MODIFICATION No.: 23143K2664 ATA SYSTEM: 21

T I T L E : AIR CONDITIONING - AIR COOLING SYSTEM - INTRODUCE AIR CONDITIONING

PACK PN 744A0000-09

Herewith Revision No. 1 of Service Bulletin A320-21-1058.

Location of Air Conditioning Packs
Figure 1

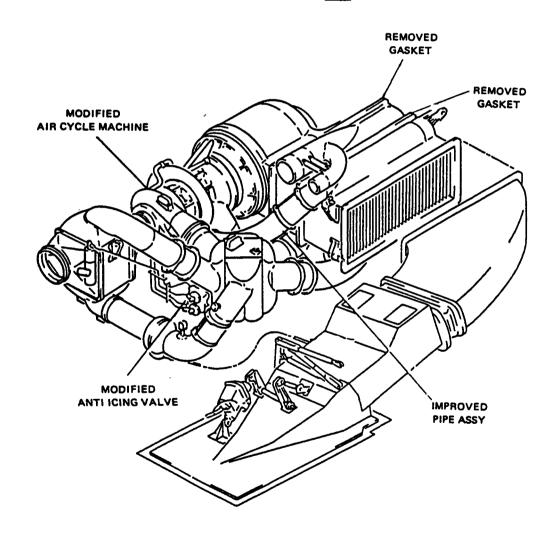
- (1) Modification of air conditioning pack from (standard-08) to (standard-09) as per LIEBHERR ABG SEMCA Service Bulletin No. 744A-21-06.
 - (a) For the replacement of the air cycle machine refer to AMM 21-52-21, P. Block 401 and Service Bulletin A320-21-1064.
 - (b) For removal of the gaskets refer to AMM 21-52-25, P. Block 401 and AMM 21-52-26, P. Block 401.
 - (c) For the replacement of pipe assemblies refer to AMM 21-52-23, P. Block 401.
 - (d) For the replacement of anti-icing valve refer to AMM 21-61-41, P. Block 401 and Service Bulletin A320-21-1065.
